SUBJECT: COMANCHE PEAK STEAM ELECTRIC STATION (CPSES)
DOCKET NOS. 50-445 AND 50-446
ADVANCE FSAR SUBMITTAL
ASYMMETRIC PRESSURIZATION LOADS FOR THE
STEAM GENERATORS

This letter provides an advance copy of a change to be included in a future FSAR amendment. This change incorporates corrected information on asymmetric pressure loads for the Steam Generators.

Advance FSAR Submittal Concerning
Asymmetric Pressurization Loads
for the Steam Generators

FIGURE 6.2.1-60

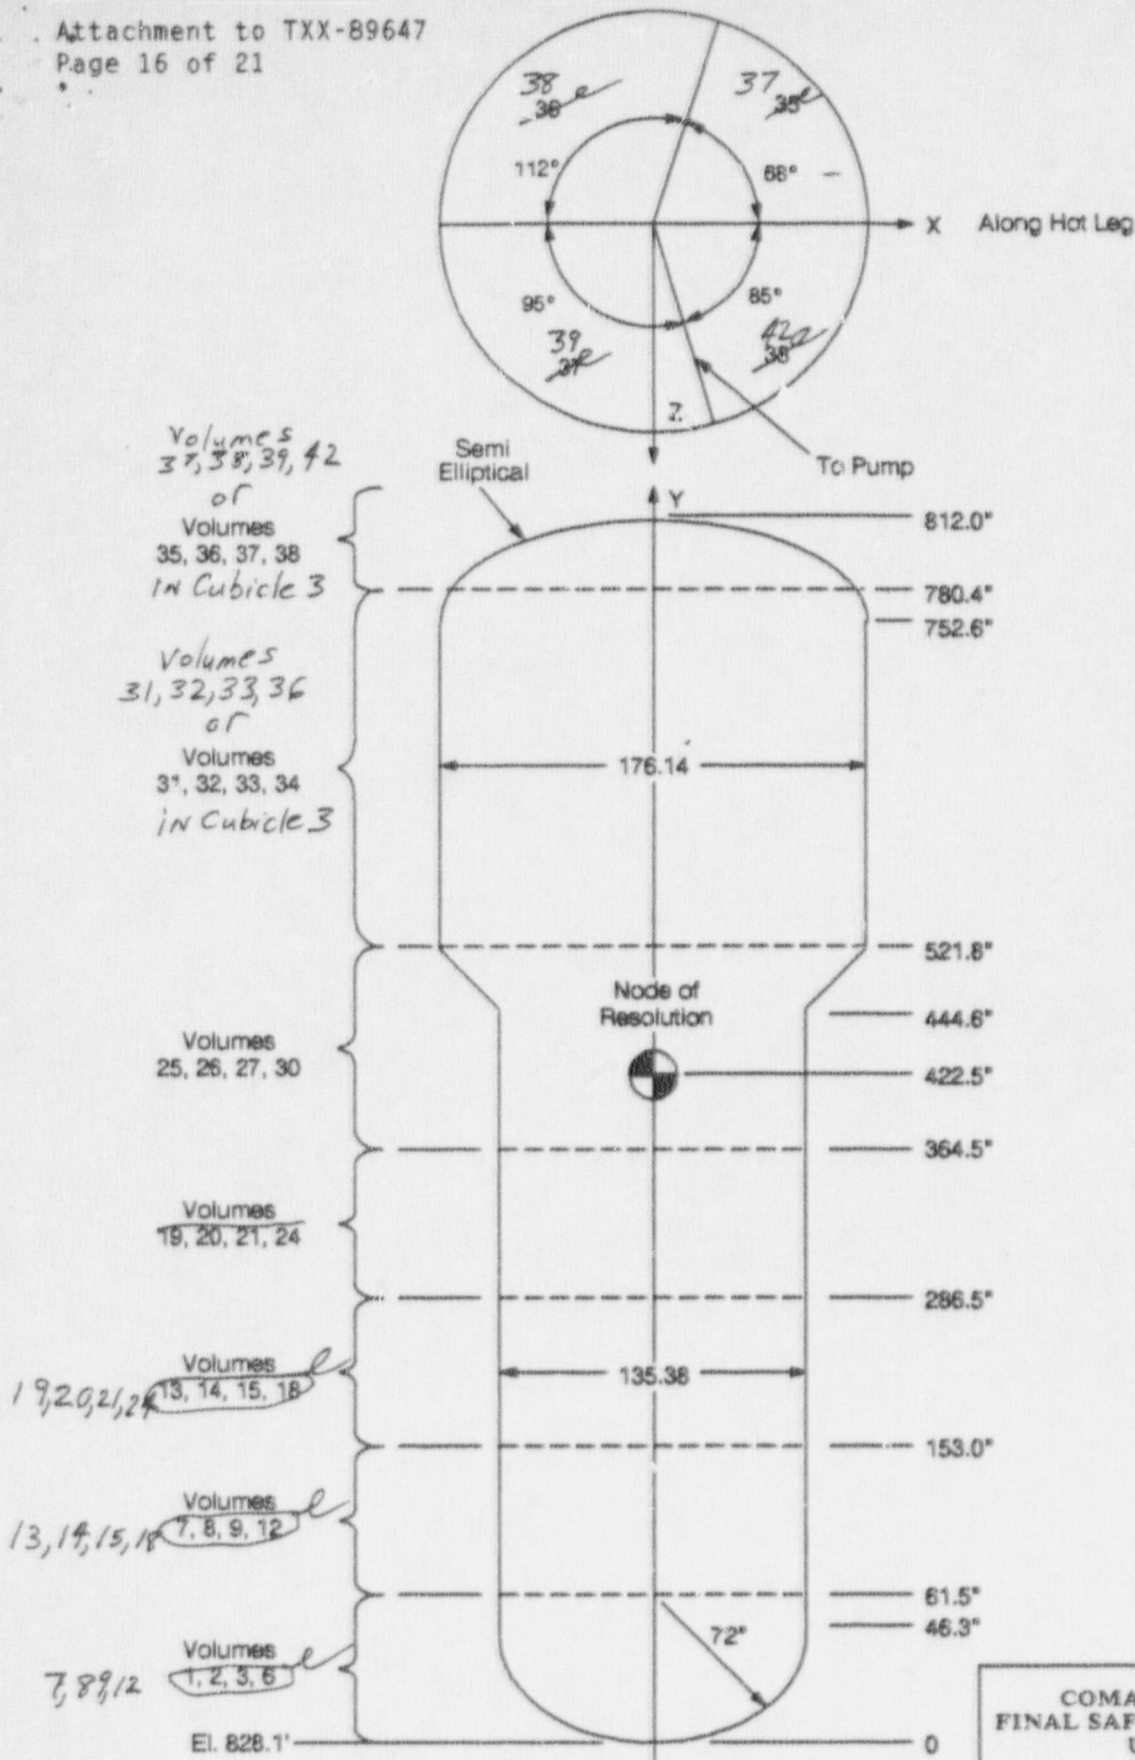
Figures reflect a reconciliation of nodalization inconsistency between the steam generator and subcompartment elevations.

16. The FSAR has revised tables 6.2.1-94, 6.2.1-95 and figures 6.2.1-60, 6.2.1-63 to incorporate corrected pressure loads on the Steam Generators.

See Justification For Tables 6.2.1-94 and 95.
